**E8257D-22**

**S E R V I C E N O T E**

**E8257D Analog Signal Generator**

**Intermittent power supply shutdown**

Figure 1

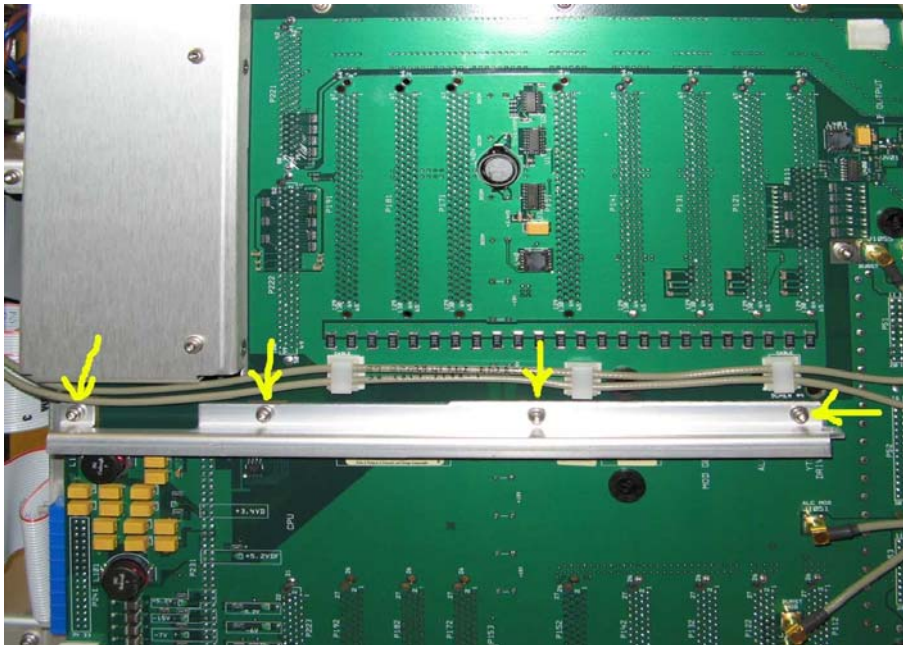
1. Remove the external cover using the procedure outlined in the service guide.
2. Position the instrument so the mother board is up. Loosen the 4 screws on the mother board stiffener shown in Figure 1.

9. Position the instrument so the mother board divider is visible and tighten the 4 screws that were loosened in Step 2 Figure 1. (Torque the T-10 screws to 9 in-lbs.)

Figure 2

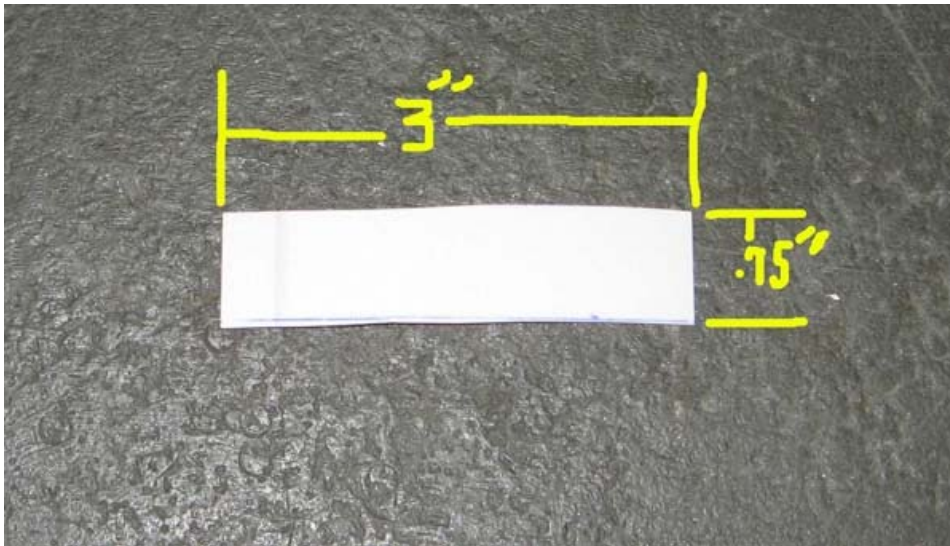
4. Cut the N8210-40002 into strips 3" long and 3/4" wide as shown in Figure 2. Only 1 strip is needed per instrument. The remaining material can be used for other instruments.

Figure 3

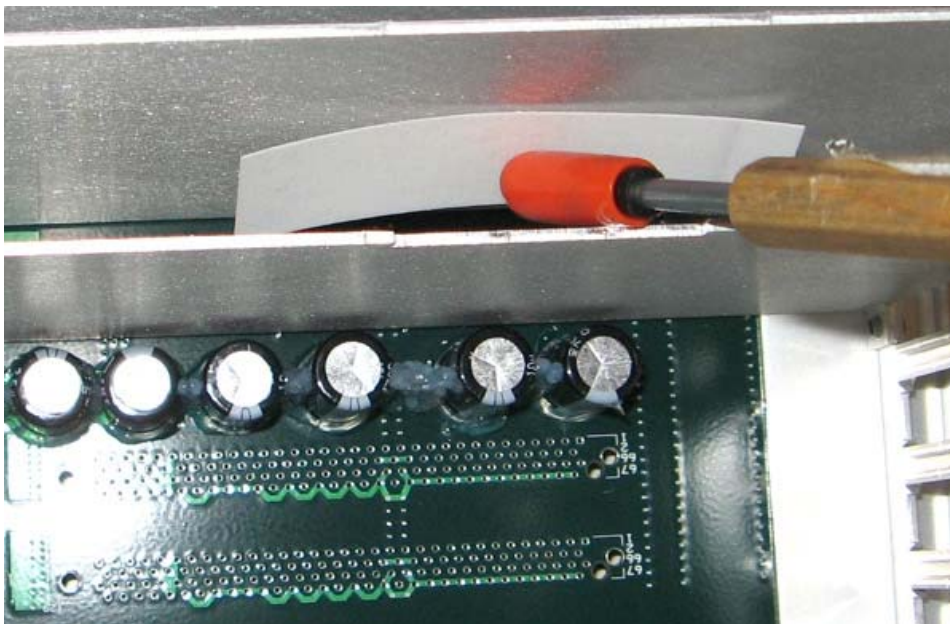
5. The next step is to slide the insulating material (sticky side up) between the card cage and the mother board. To position the insulating material, lightly attach it to a steel ruler or some other ESD safe item that can be used reach down into the tight space. Refer to Figure 3.

6. Start by placing the insulating material against the back wall (sticky side away from the wall) and then slide it down until the front edge of the strip is against the mother board. Once the front edge is against the mother board slide the insulator forward under the divider. If it does not want to slide forward under the divider lightly press down on the mother board near C435. Refer to Figure 3.

Figure 4

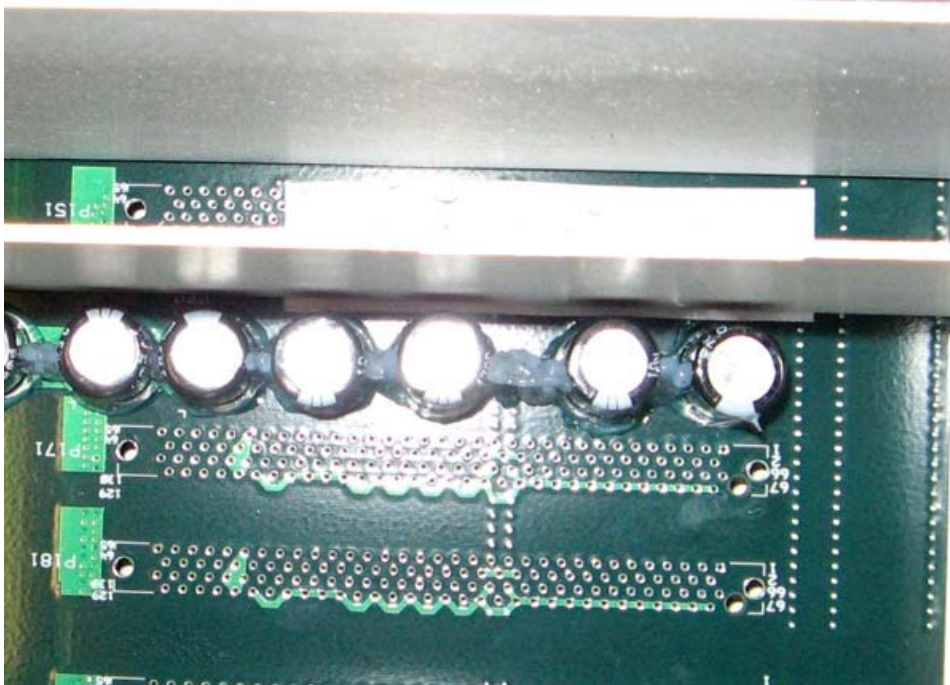
7. Position the insulator so that it can be seen on both sides of the divider and that it covers the area under the divider between the 4 larger capacitors on the right side as shown in Figure 4.
